AGENDA
Regular Hybrid Meeting
Town of Granby
Planning & Zoning Commission
Tuesday, July 22, 2025, at 7:00 pm
Town Hall Meeting Room

a. Application seeking a 7-lot subdivision, Breezy Meadow, for property located at 188 Day Street, R30 and R50 Zones: File P-1-25.

Subdivision Application Plan Review

Breezy Meadow Subdivision, Prepared for Peak Mountain Development, LLC, 188 Day Street, December 23, 2024, Sheets: SD-1, GR-1, GR-2 E&SC-1, E&SC-2, Notes-1, Alford Associates, Inc., last revised 7/15/25.”

Day Street Streetscape

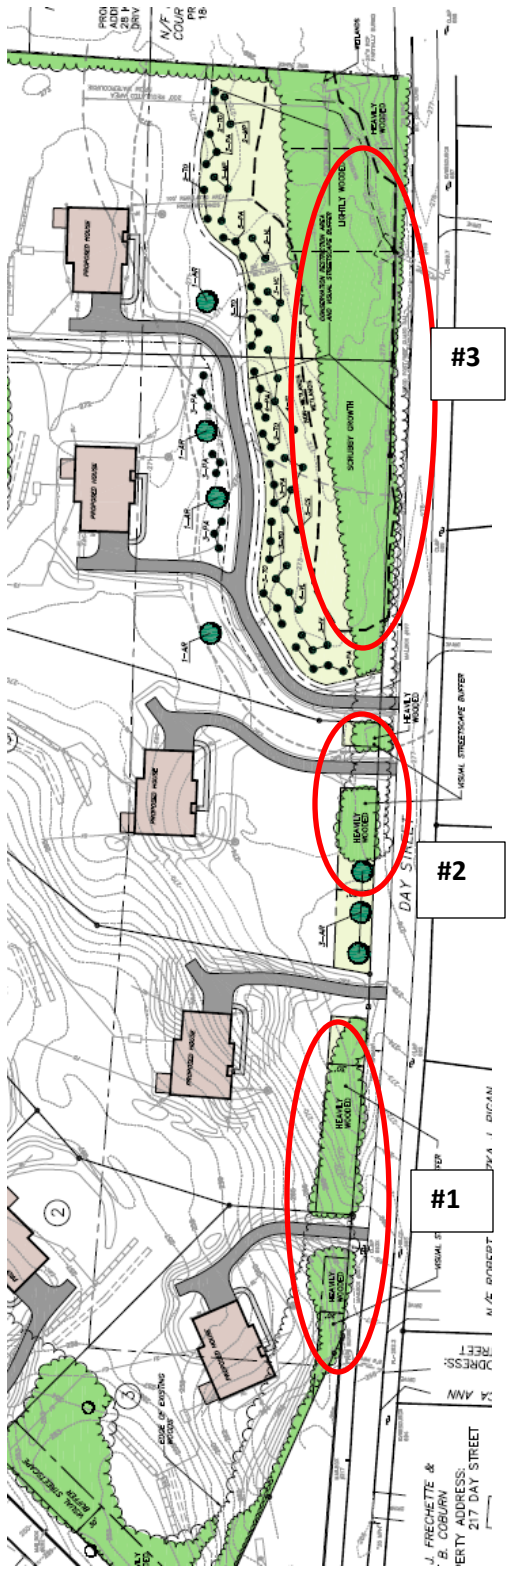
#1 View looking south: lots 3 and 4 behind wooded area

#2 View looking south: cleared area includes part of lot 4 where driveway is proposed and lot 5
Tree/vegetated area is the “heavily wooded” area marked on lot 5 on VPPP-1

#3 View looking south: “scrubby growth area” marked on lots 6 and 7 on VPPP-1 (wetland area)

Sheet
GR-1

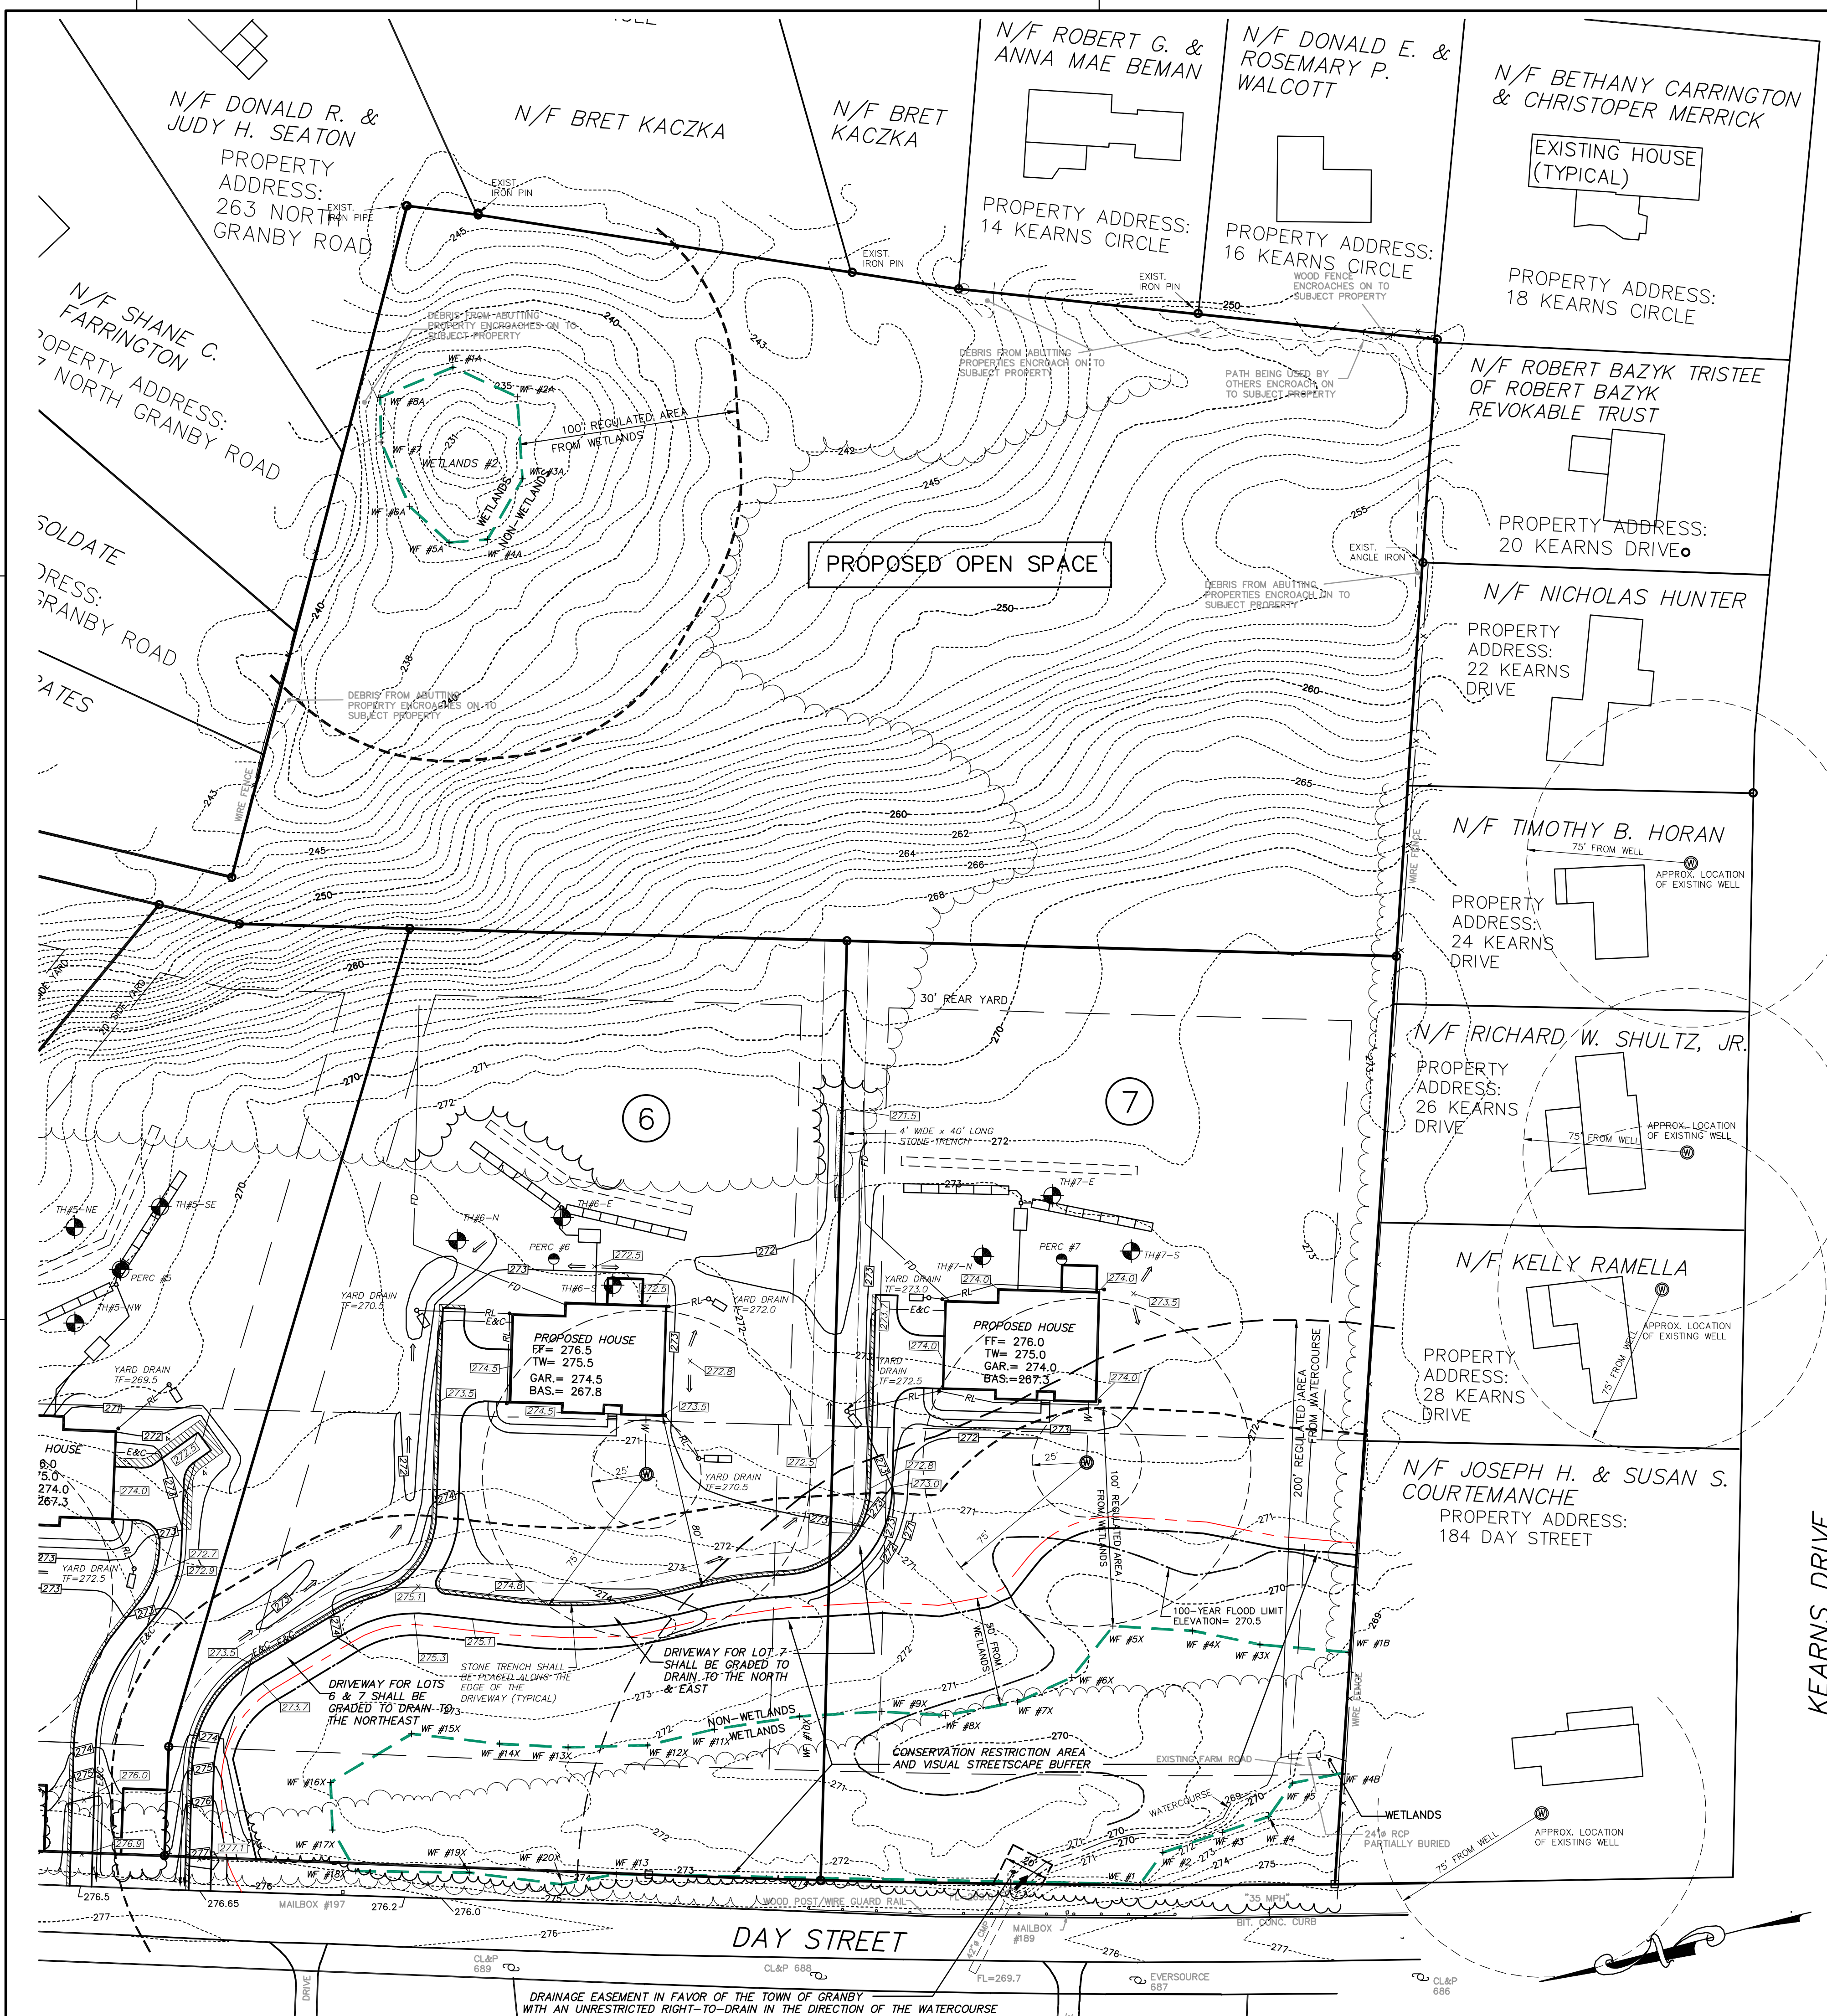
Sheets GR-1, 2, &3

1. If possible, reduce the length of the swale on the west side of lot 3. Raising the house elevation may be beneficial. Long swales can be difficult for a homeowner to maintain.
2. Eliminate swale on north side of driveway to lot 6. Allow water to sheet drain across the lawn area.
3. Rain gardens (shallow basin at roof infiltration systems) still shown on the plans. Eliminate to allow for sheet drainage and remove from detail sheet.
4. Verify line-of-sight for driveway to Lot 3.
5. Plans to be revised as necessary to comply with FVHD letter dated 7/7/25. Resubmit to FVHD and submit final approval letter.
